Application for Works Approval Amendment

Works Approval Number	W6578/2021/1
Works Approval Holder	FQM Australia Nickel Pty Ltd
ACN	135 761 465
File Number	DER2021/000358
Premises	Ravensthorpe Nickel Operations Legal description – Part of Mining Tenements M74/175, M74/115 and M74/116 JERDACUTTUP WA 6346 As defined by the Premises maps attached to the revised works approval
Date of Report	23 May 2022
Proposed Decision	Revised works approval granted

Figure 2: Standing water level for groundwater monitoring bores south of TSF2.

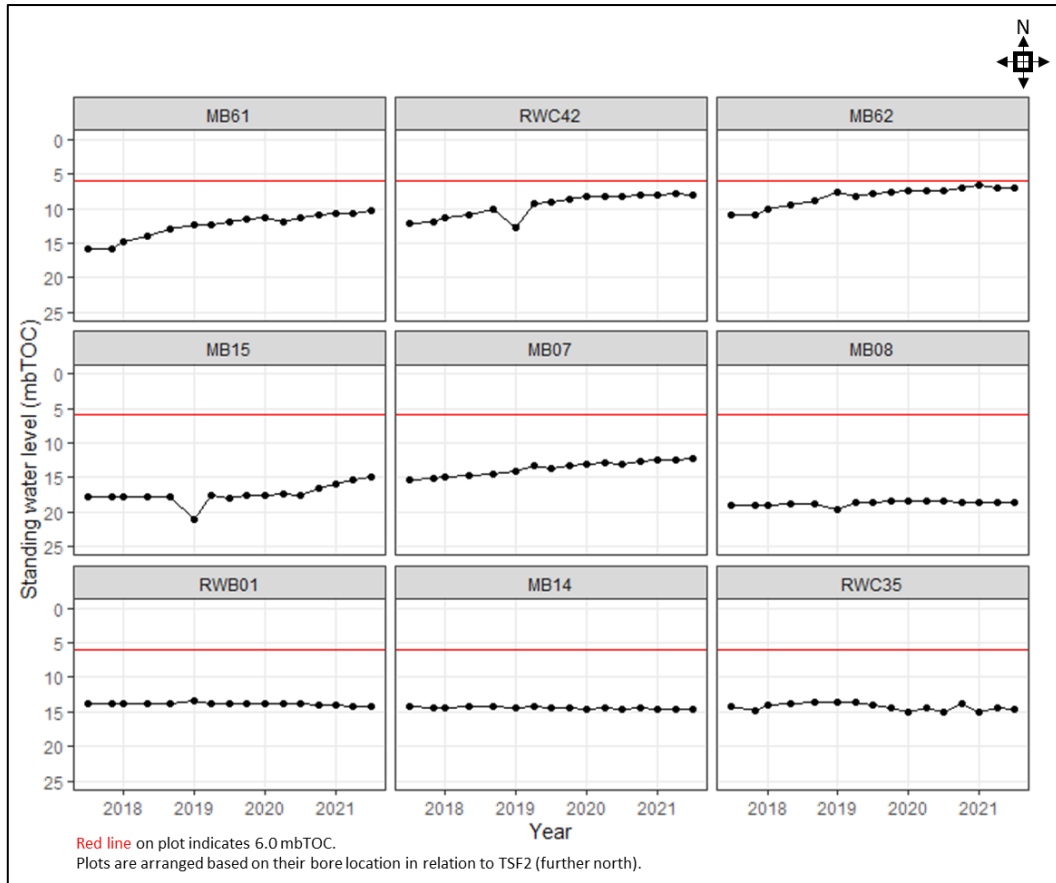
Groundwater mounding as a result of seepage from TSF2 has been observed in the existing groundwater bore network. The extent of mounding is most severe to the south of TSF2, dissipating with distance from the TSF (Figure 2). Based on monitoring data provided by the Works Approval Holder up to July 2021, SWL at the TSF2 southern embankment is becoming increasingly shallower, with the SWL of MB62 at 6.96 mbTOC (metres below top of casing) in July 2021. While there is no limit for SWL specified in licence L8008/2004/3, the rising trend in SWL represents an increasing risk towards nearby sensitive receptors.

Figure 3: Proposed location of seepage collection drain and sump, in relation to proposed recovery bores

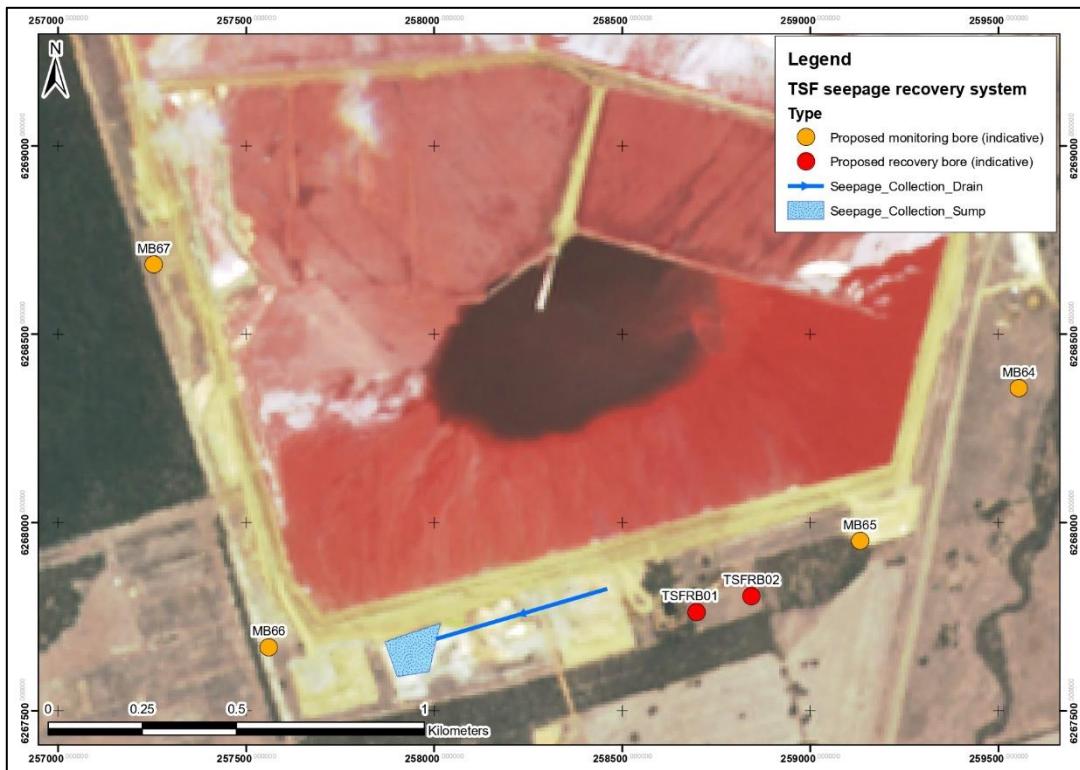
Specifically, the seepage collection system will be constructed along the southern embankment of TSF2, where groundwater mounding was most severe. The location of the seepage collection drain would be close to the seepage recovery bores and will likely be able to capture some degree of seepage prior to the construction of the bores.

Given the controls in place and the standing water level trends, the requested seven-month extension for bore construction is unlikely to significantly increase groundwater mounding due to seepage, and hence the risk of impact to receptors. The delay in constructing the required groundwater monitoring bores would result in reduced data for monitoring groundwater mounding but would not represent any direct impact to the environment. The expected incremental increase in seepage due to continued tailings deposition into TSF2 over an additional seven months is likely to be adequately managed by the controls in Section 3.3.2, in spite of the deferred construction of the seepage recovery bores.
